SCHWEIZER SERVICE NOTICE

NOTICE NO. N-204

SUBJECT: IDENTIFICATION AND POSSIBLE REPLACEMENT OF COLLECTIVE PITCH MIXER BELLCRANK.

MODELS AFFECTED: ● All Model 269A, 269(TH-55A), 269A-1, 269B Helicopters.
● All Model 269C Helicopters having a serial number prior to 1274.
● All 269A7522 Collective Pitch Mixer Bellcranks in spares inventory.

FIGURE 1. COLLECTIVE PITCH MIXER BELLCRANK

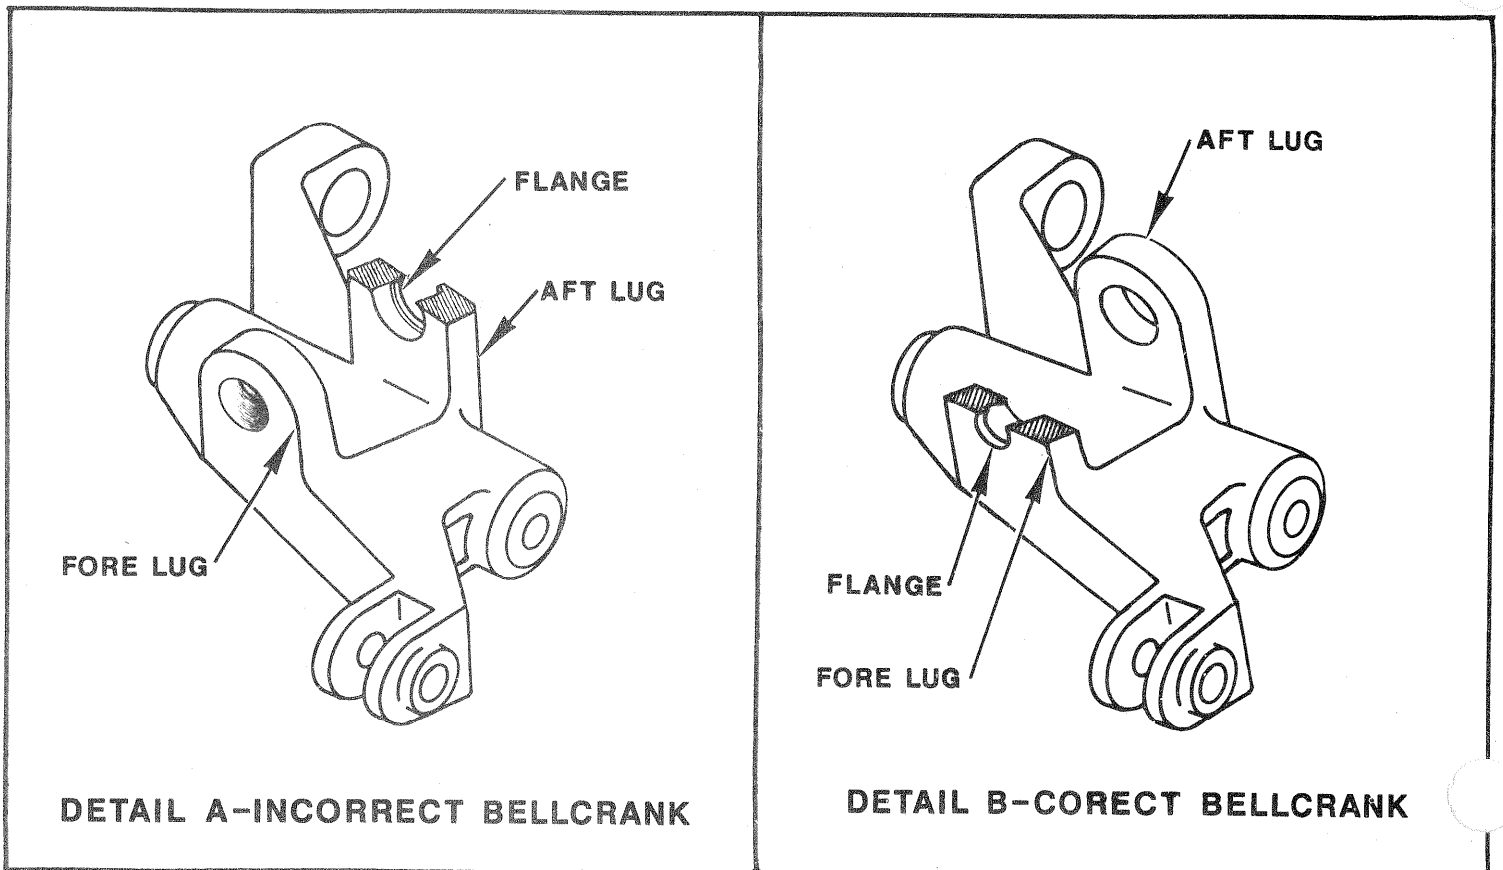
PREFACE: A possibility exists that some 269 Series Helicopters may be equipped with an incorrect collective pitch mixer bellcrank. The incorrect bellcrank incorporates a flange on the aft lug bearing bore ID (Figure 1, Detail A). The correct bellcrank possesses the flange on the fore lug bearing bore ID (Figure 1, Detail B). In addition to this flange (on the fore lug bearing bore ID), the collective pitch mixer bellcrank should incorporate a rounded edge (.12 inch radius) on the lower right-hand edge of the bellcrank aft arm (Figure 3). Bellcranks which do not incorporate this rounded edge may cause damage to the bellcrank support mast lug if the aft arm is allowed to swing down and hit the lug (when the controls are disconnected).

The incorrect collective pitch mixer bellcrank incorporates a flange on the aft lug bearing bore ID (Figure 1, Detail A). The correct bellcrank possesses the flange on the fore lug bearing bore ID (Figure 1, Detail B).

- (2) Using a correct collective pitch mixer bellcrank (Figure 1, Detail B), reassemble components in accordance with Basic HMI, paragraph 8-109.
- e. Check the lower right-hand edge of the bellcrank aft arm (for a rounded corner) as follows:
- (1) If installed, remove right-hand side fuel tank in accordance with Basic HMI, Section 5 to gain access to bellcrank aft arm.
 - (2) Check the lower right-hand edge of the bellcrank aft arm for a round corner. (Refer to Figure 3.)

Ensure that the slotted bushing shown in Figure 1 is installed before installing bolt in next step.

- (1) With one washer installed on bolt, reattach control rod to bellcrank by inserting bolt through bellcrank and control rod. (Refer to Figure 1.)
 - (2) Secure bolt with washer, nut and cotter pin. (Refer to Figure 1.)
 - (3) Use glue to reinstall plastic boot between pilot and copilot seats.
 - (4) Reinstall center cover.
- g. Check and adjust rigging as required in accordance with Basic HMI, Section 8.
- h. Record compliance with this Service Information Notice in Compliance Record of Helicopter Log Book.

FIGURE 2. COLLECTIVE PITCH MIXER BELLCRANK
DIMENSIONAL REQUIREMENTS

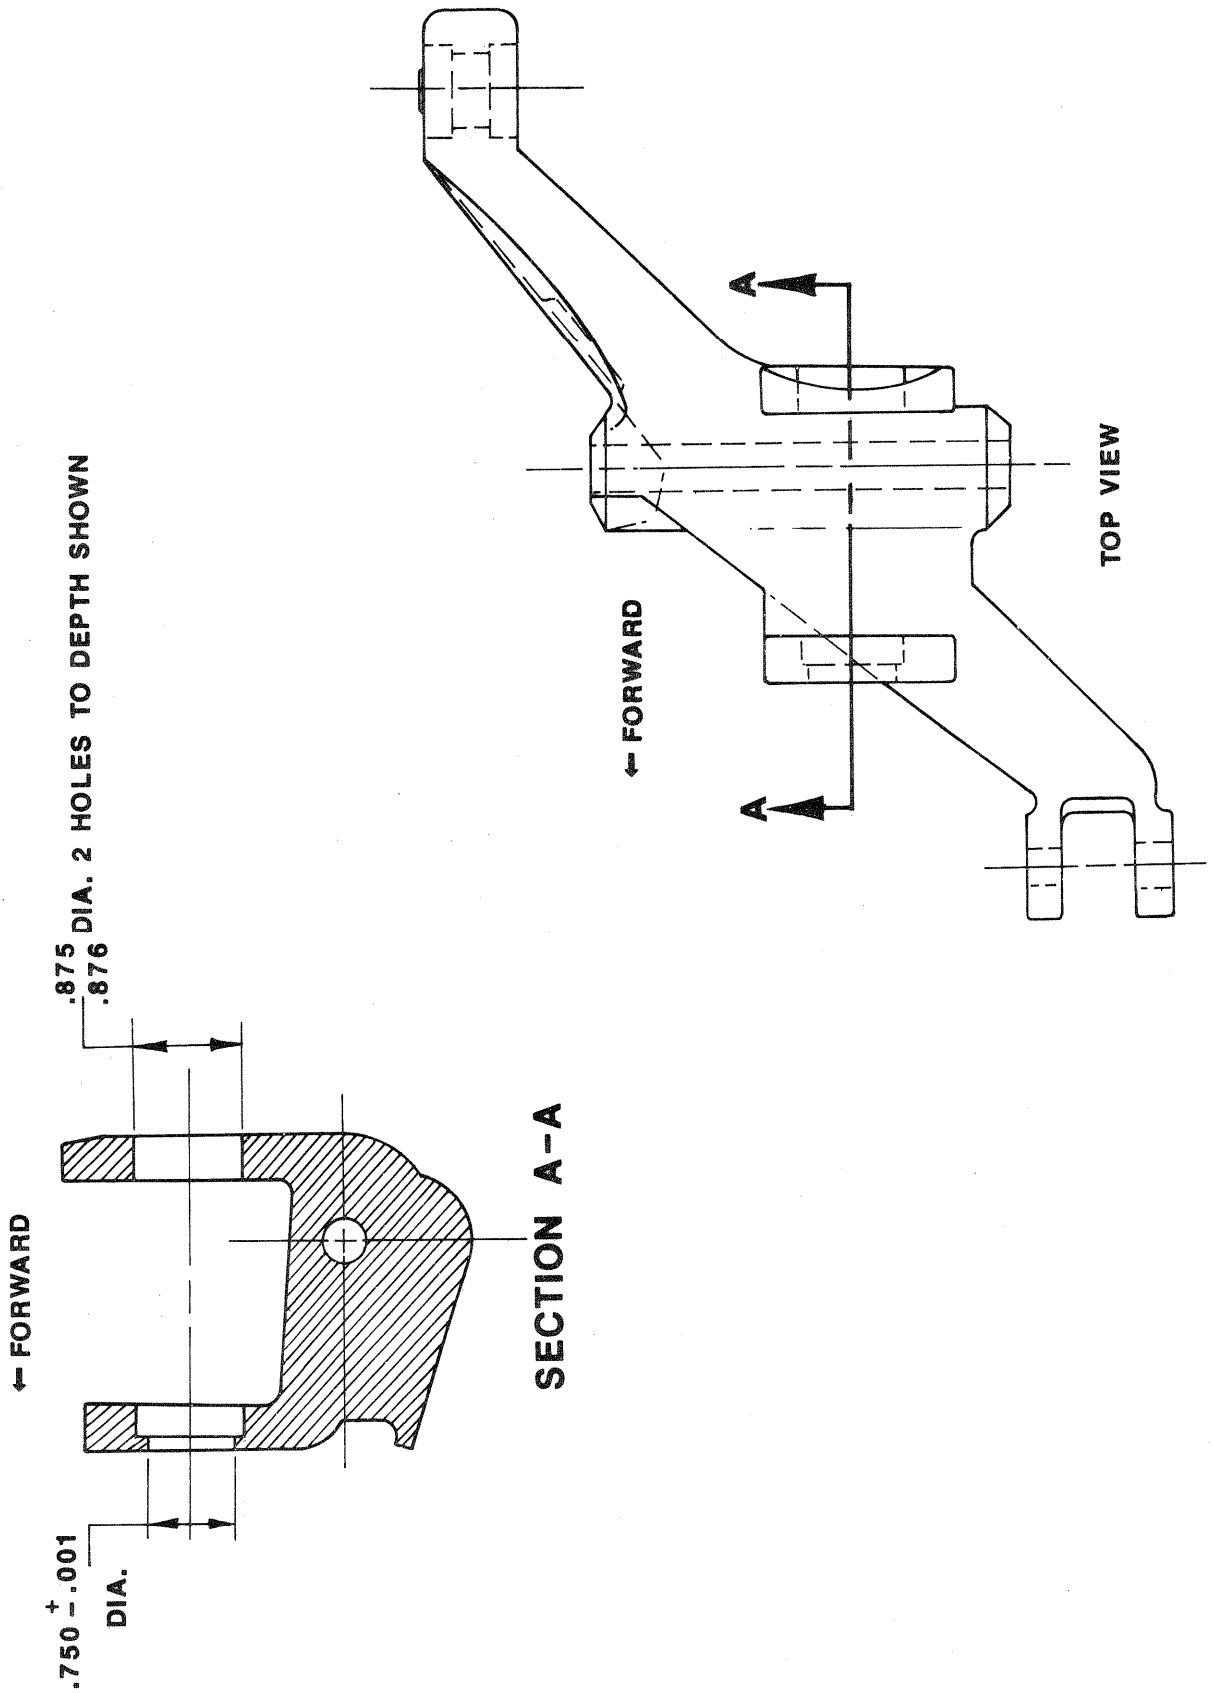
- (1) Using a suitable measuring device, determine the ID at the aft edge of the aft lug bearing bore and the ID at the fwd edge of the fore lug bearing bore. (Refer to Figure 2, Section A-A for measurement locations and requirements.)
- (2) Remove from stock all 269A7522 bellcranks which do not meet the dimensional requirements of Figure 2, Section A-A. (Contact your SAC Customer Service Center or Distributor for disposition of incorrect bellcranks.)

- (2) Remove plastic boot from seat structure panel between pilot and copilot seats.
 - (3) Using a suitable measuring device, determine the ID at the fwd edge of the fore lug bearing bore. (Refer to Figure 2, Section A-A.)

- (4) If the dimension measured in the previous step is not within the required limits (0.750 \pm 0.001-inch), remove and replace the bellcrank (PN 269A7522) in accordance with step d below.

- (3) Push downwards on the forward arm of the collective pitch mixer bellcrank. (Refer to Figure 1.)
 - (4) Using a suitable measuring device, determine the ID at the aft edge of aft lug bearing bore. (Refer to Figure 2, Section A-A.)
 - (5) If the dimension measured in previous step is not within the required limits (.875 to .876-inch), remove and replace bellcrank in accordance with step d (below).
- d. If either the fore lug bearing bore ID or the aft lug bearing bore ID is not within the required limits (as determined in steps b and c, respectively), remove and replace bellcrank as follows:
- (1) Remove collective pitch mixer bellcrank in accordance with Basic HMI, paragraph 8-105. (Contact your SAC Distributor or Service Center for disposition of removed bellcrank.)

FIGURE 3. COLLECTIVE PITCH MIXER BELLCRANK

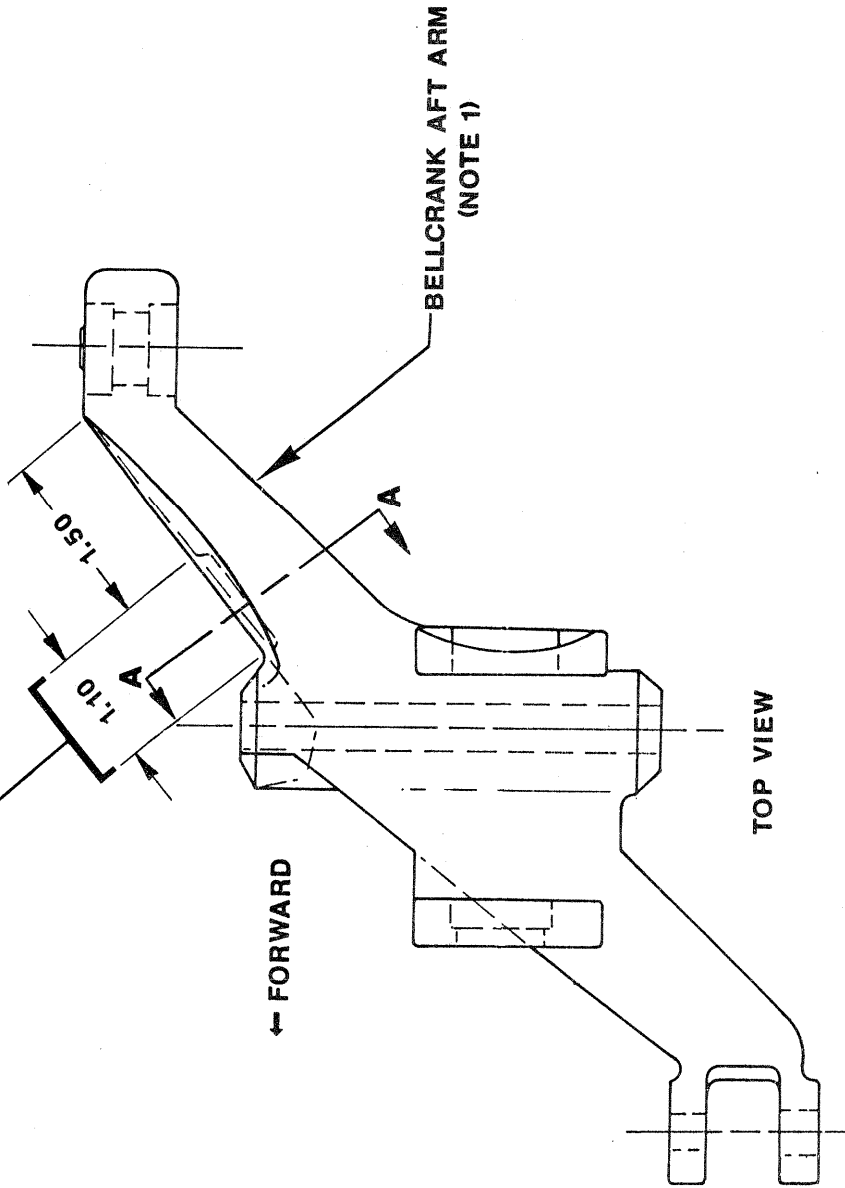
If the lower right-hand edge of the bellcrank aft arm is not round, it is possible (when control rods are disconnected) for the bellcrank aft arm to swing down and nick the bellcrank support mast lug. Bellcranks that do not possess a rounded corner at the lower right-hand edge of the aft arm, must be modified in accordance with step e.

- (3) If the bellcrank meets the dimensional requirements of Figure 2, check that the lower right-hand edge of the bellcrank aft arm is round. (Refer to Figure 3.) If this edge is not round, modify the bellcrank in accordance with step e. (below).

- (3) If lower right-hand edge is not round, use progressively finer grades of abrasive materials to make edge round. (Refer to Figure 3.) Polish smooth with abrasive paper, not coarser than 360 grit.

NOTE 1. CHECK THAT LOWER R.H. EDGE OF
BELLCRANK ARM IS ROUND. IF EDGE IS
NOT ROUND, USE FILE TO INSTALL A
.12 INCH RADIUS (APPROX.).

.12 R FOR 1.10 LENGTH
(APPROX.)

EDGE MUST BE ROUNDED
IN THIS AREA.

FIGURE 4. DYE-PENETRANT INSPECTION OF MAST LUG

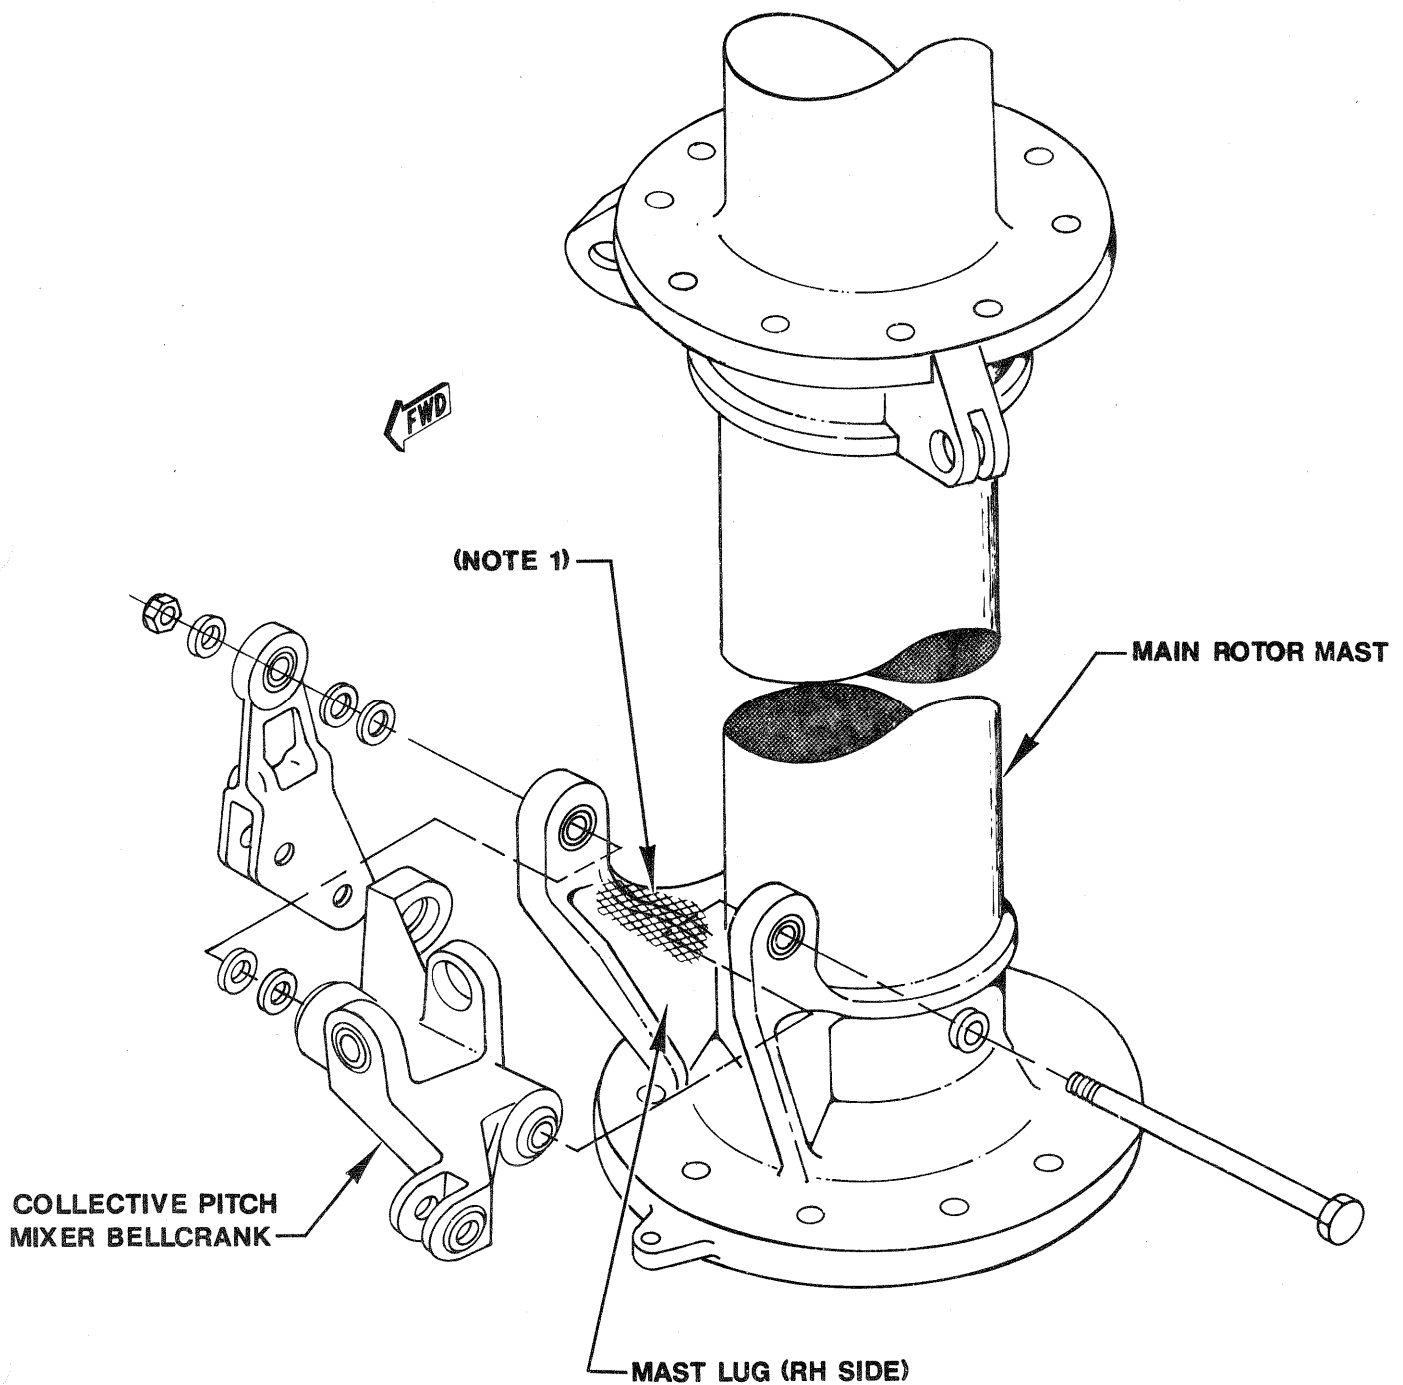
- (4) Check right mast lug for nicks (caused by bellcrank). (Refer to Figure 4.)
 - (5) If any nicks are found in mast lug, feather out nicks with a fine file. Polish smooth with abrasive paper.

- (6) If nicks are found, strip paint and dye-penetrant inspect mast lugs for cracks in accordance with Basic HMI, Section 13. If cracks are found, replace mast. If mast is still serviceable, treat lug with Dow #19 and repaint in accordance with Basic HMI, Section 2.

**NOTE 1. DYE-PENETRANT INSPECT
SHADED AREA FOR CRACKS.**
